PL 25-198 Poverty Flats UP 23-09 IS 23-20

Chapter 4 Grading – Grading Non-Compliance and Mitigation Nullification

Figure B3: Google Earth Pro image of Poverty Flats Property April 18, 2021 showing original trail/road (red line), removal for culvert installation area, and enlarged cuts and new road.

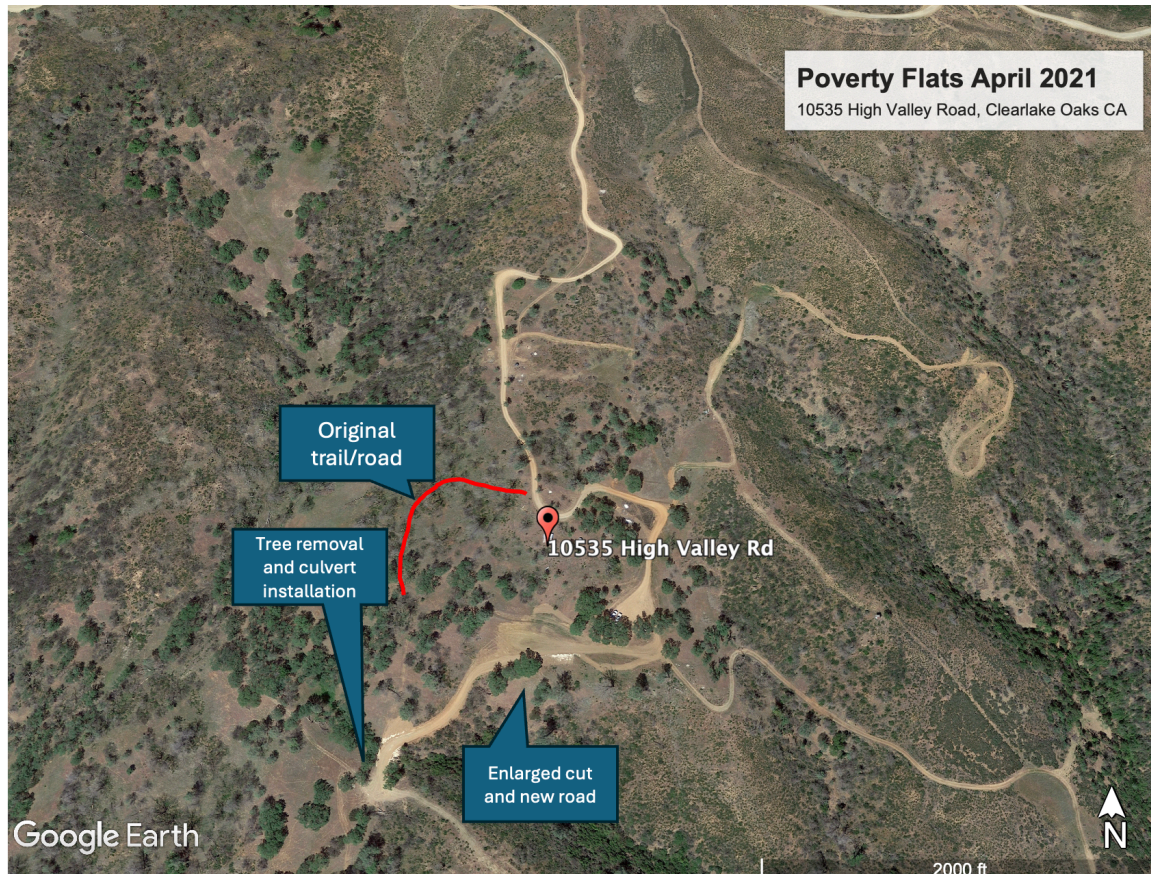
- By April 18, 2021 aeriels (Figure B3) capture grading/trenching and tree removal before any grading permit or Lake Streambed Alteration Agreement, while applicant emails seek permits for canopy preparation after grading began [A5]. Applicant stated that CalFire graded fire breaks after the Mendocino Complex Fire but aerial imagery shows otherwise [A6].

Figure B5: Google Earth Pro image of Poverty Flats Property on October 9, 2022 showing six months of continued grading under ministerial permit GR 22-12.

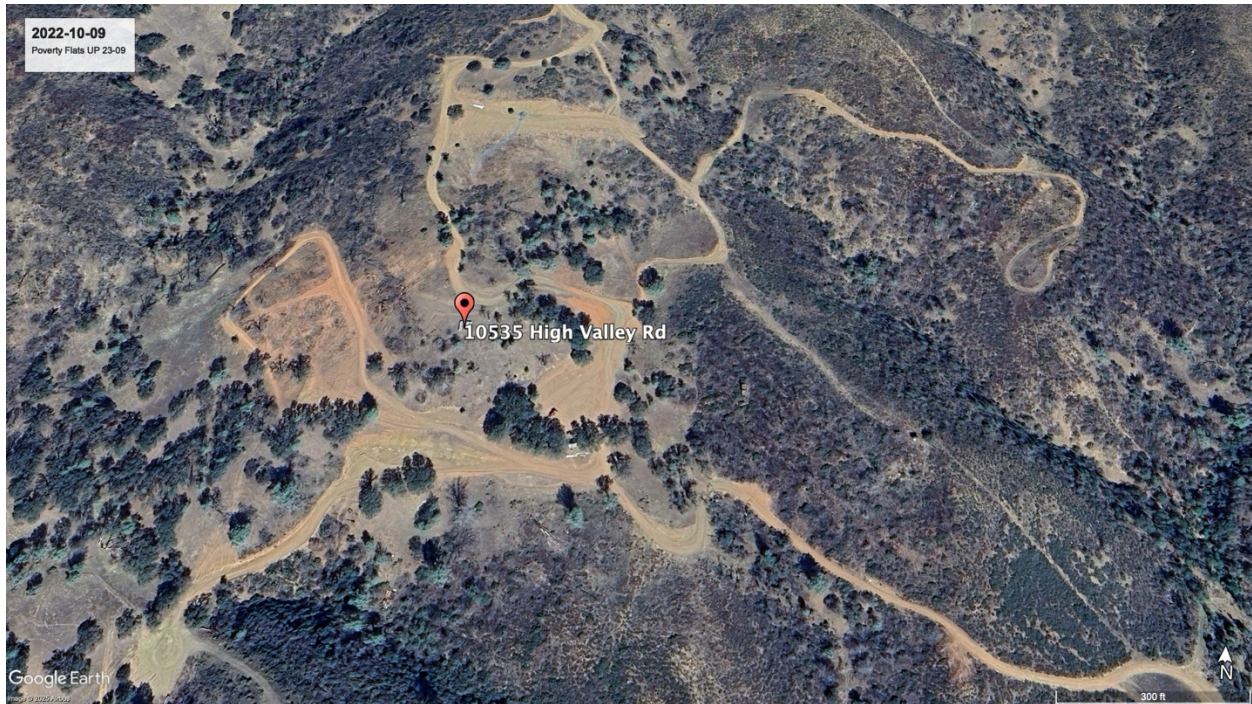
- Permit GR22-12 “with conditions” (issued 4/14/2022) authorizes “clearing and maintenance of existing firebreak” and “road maintenance/widening to 4290 only in <20% slopes and areas wide enough” with “minimal soil disturbance.” Public Records Request returned no requested copy of permit conditions. [A7]
- Subsequent imagery and cultural documentation show pad cuts, widened benches, and ~3-ft trenches aligned to cultivation areas—characteristic of complex grading, not ministerial maintenance. [A8] (Figures B4, B5, B6)

Figure B8: Timeline of permit mishandling that should have triggered ISMND recirculation.

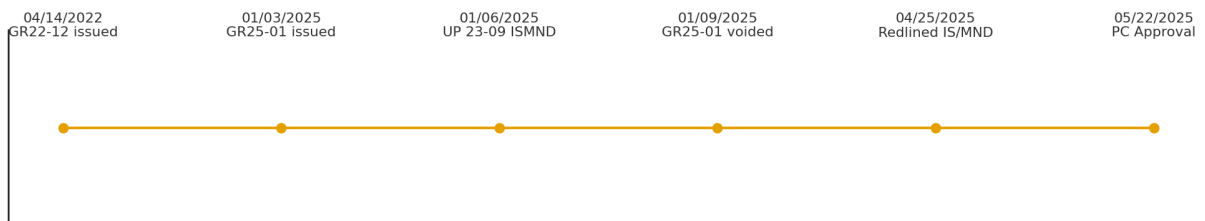
- The county discusses the grading activity and attempts to incorporate the grading that has been done “*A complex grading process will be necessary for this project, and management is currently exploring options to incorporate the grading permit.*” [A11].
- Complex Grading Permit GR25-01 was issued January 9, 2025 for ~7,450 CY earthwork, culvert/trenching [A12]. The ISMND dated January 6, 2025 incorporates the complex permit and references an existing 18" HDPE culvert [A13]. This is the version that was uploaded to CEQA on January 9, 2025 with the Preliminary Grading Plans and other documents.
- On January 9, 2025 staff email requests voiding GR25-01. [A14]

- March 24, 2025 Email from Tod Elliott to Max Stockton citing Sec.30-17. - Exemptions 30-17.4.13 Grading for water well pads or utilities [A15]. This additional and separate grading activity should have been incorporated in the total of the project and constitutes a piecemealing of the project components which violates several CEQA guidelines [A16].
- May 22, 2025 Planning packet presents a redlined IS/MND [A17] omitting GR25-01 while retaining intensive infrastructure descriptions—a material change from circulation to adoption. That redlined version dated April 25, 2025 was subsequently reworked to incorporate the changes and uploaded to CEQA on May 27, 2025 without the reference to GR 25-01 and without the Preliminary Grading Plans [A1].
